SUBJECT: ISSUANCE OF AMENDMENT NO. 6 TO FACILITY OPERATING LICENSE
NPF-16, ST. LUCIE PLANT, UNIT NO. 2

ST. LUCIE PLANT UNIT NO. 2

ATTACHMENT TO LICENSE AMENDMENT NO. 6
TO FACILITY OPERATING LICENSE NO. NPF-16
DOCKET NO. 50-389

SAFETY EVALUATION BY THE OFFICE OF NUCLEAR REACTOR REGULATION

Figure 3.2-2
 AXIAL SHAPE INDEX vs fraction of maximum allowable power
 level per Specification 4.2.1.3

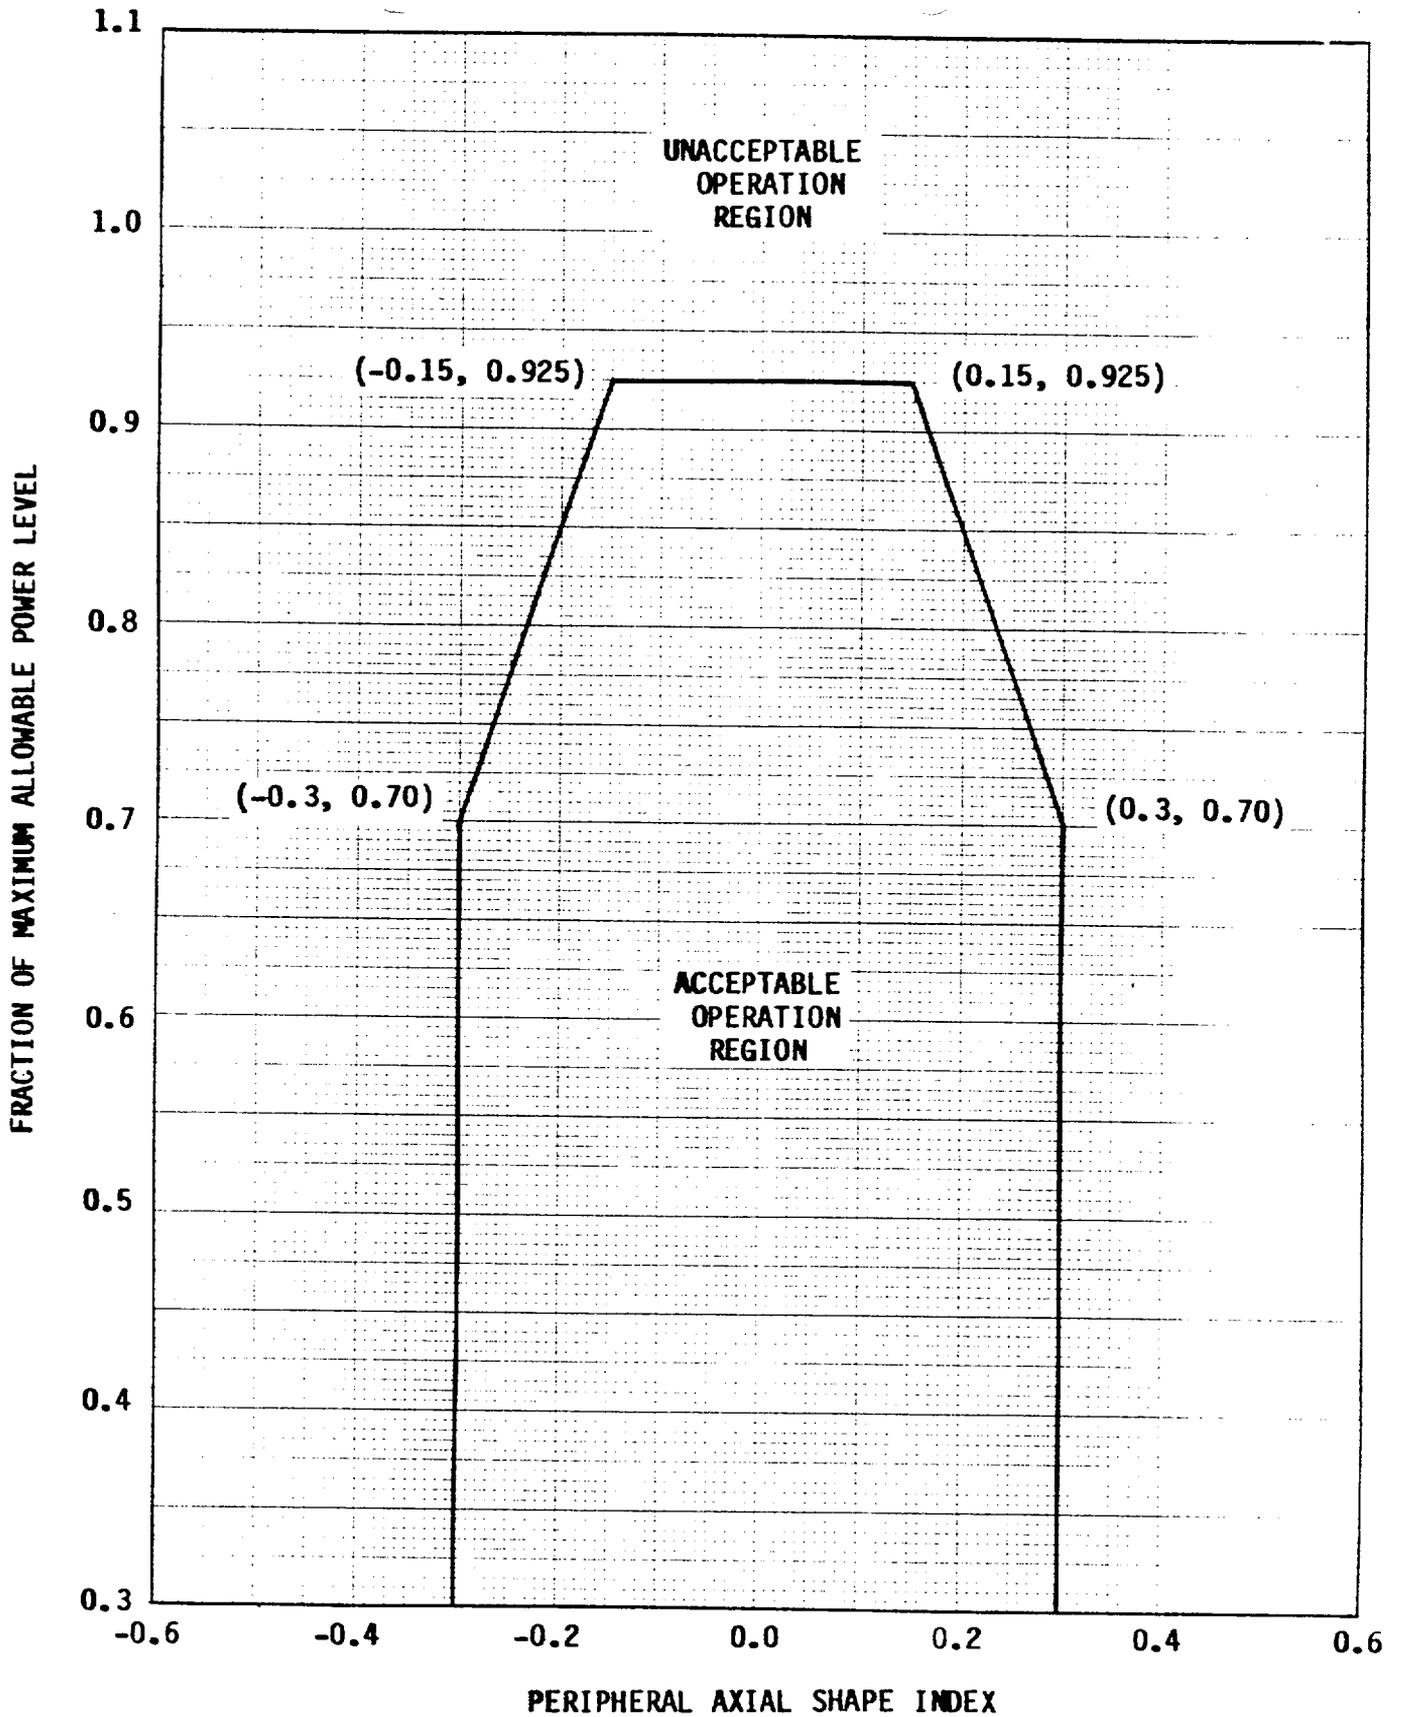
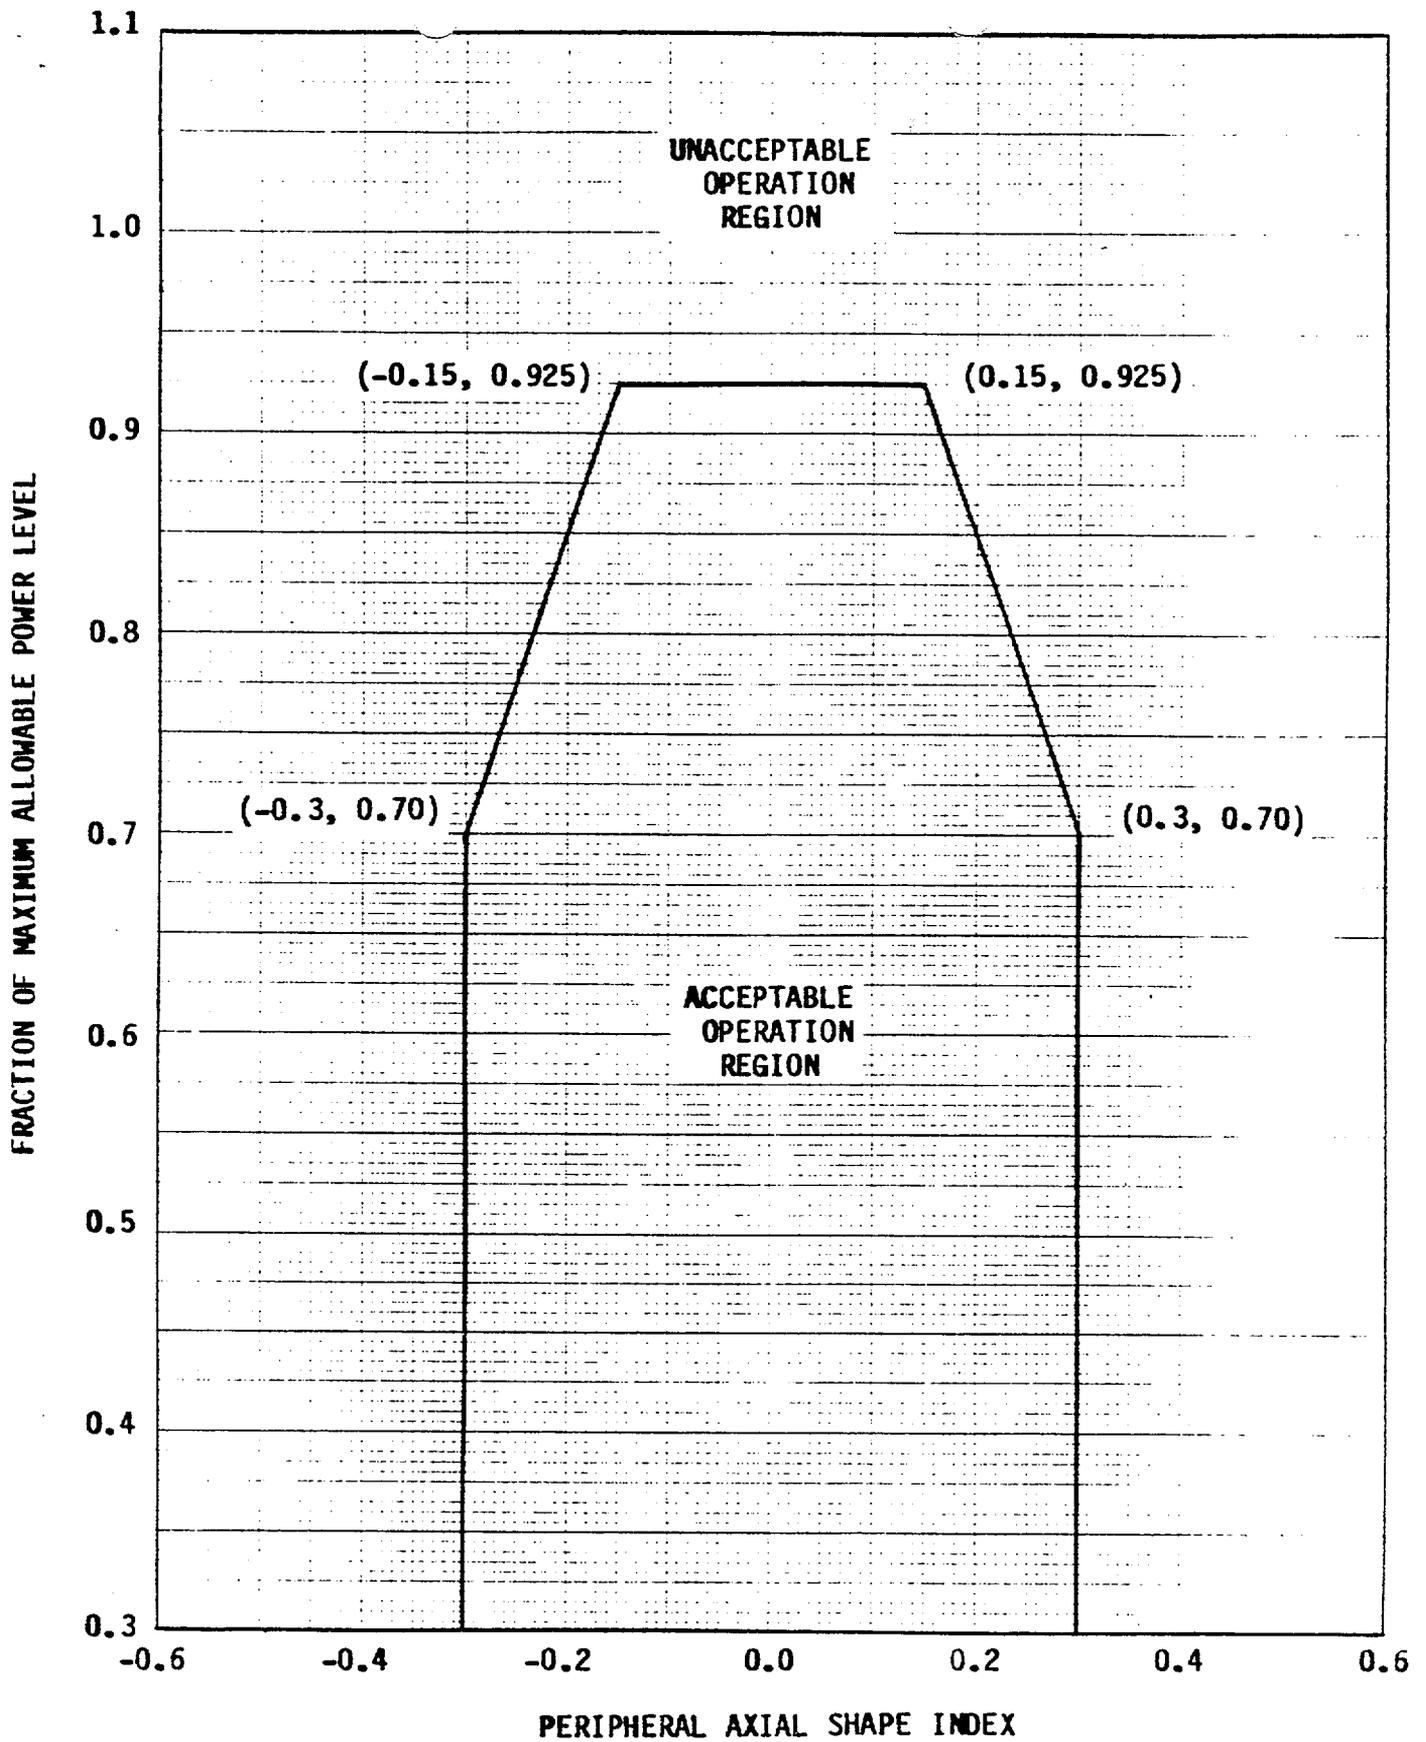
The amendment changes Axial Shape Index Figures 3.2-2 and 3.2-4 to reflect the fact that the Limiting Conditions for Operation are not needed below 30% of rated thermal power.

Figure 3.2-2 and Figure 3.2-4 of the technical specifications provide conservative calculated values of the Departure from Nucleate Boiling (DNB) LCO. As the power decreases the permitted ASI becomes larger. However, for convenience it was truncated at -0.3 and $+0.3$, but the permissible ASI continues to increase as power decreases. The Local Power Density (LPD) Limiting Safety Setting Set-points (LSSS) for St. Lucie Unit 2 likewise increases as power decreases and has values of -0.4 and $+0.4$ from 80% to 0% power. FP&L has provided data that shows that the LSSS becomes more restrictive than the DNB LCO at approximately 77% power. FP&L has also provided data that show that the LSSS continues to be more restrictive as power continues to decrease.

Based on the staff review of the data submitted, the staff agrees that the LSSS value is more restrictive than the calculated DNB LCO below 30% power. Therefore, the staff approves of the proposed technical specification change allowing the LSSS to replace the DNB LCO below 30% power.
